MIL-P-60504A(MU)
AMENDMENT 4
31 March 1972
SUPERSEDING
AMENDMENT 3
15 January 1972

MILITARY SPECIFICATION

PRINTED CIRCUIT BOARD ASSEMBLY Q-SWITCH TIMING CIRCUIT: 10541270

This amendment forms a part of Military Specification MIL-P-60504A(MU), dated 18 June 1970.

FIGURE I

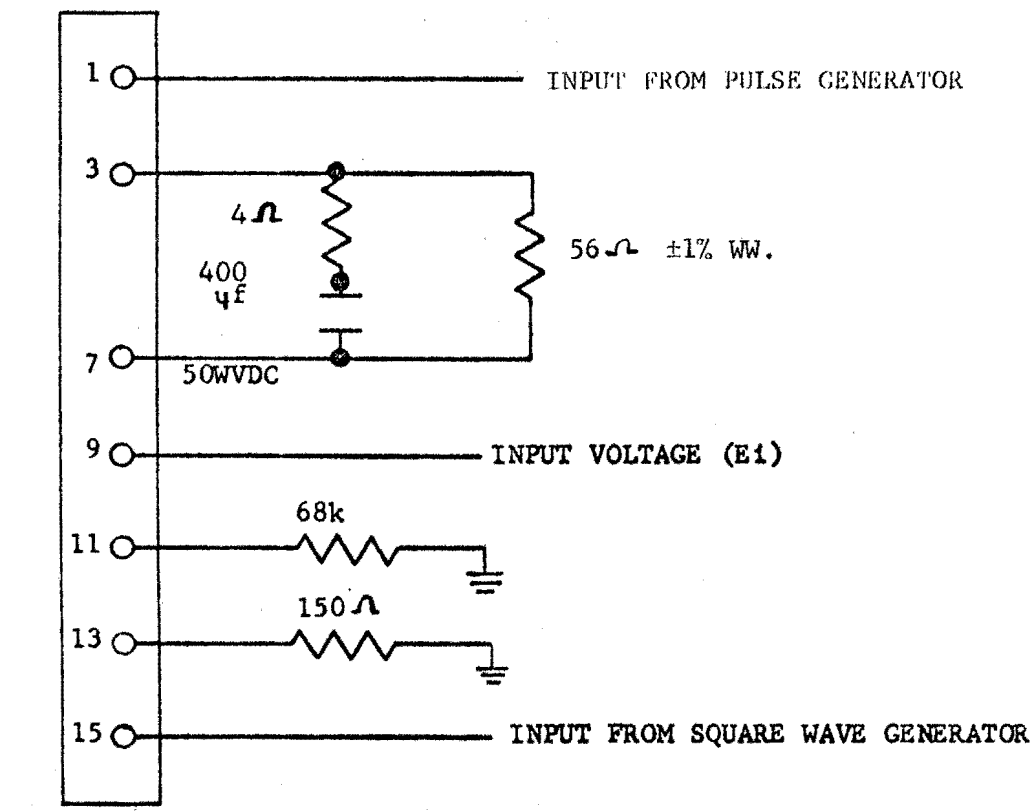
* Sheet 14 Figure 1; Delete and substitute New Figure 1.

FIGURE 2

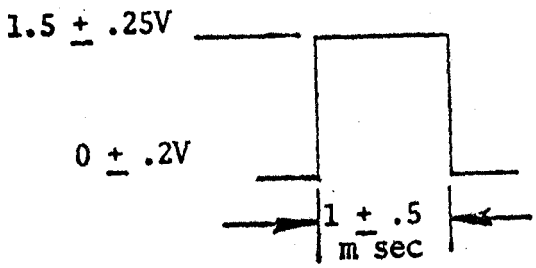
* Sheet 15 Figure 2 and 3; Delete and substitute New Figure 2 and 3.
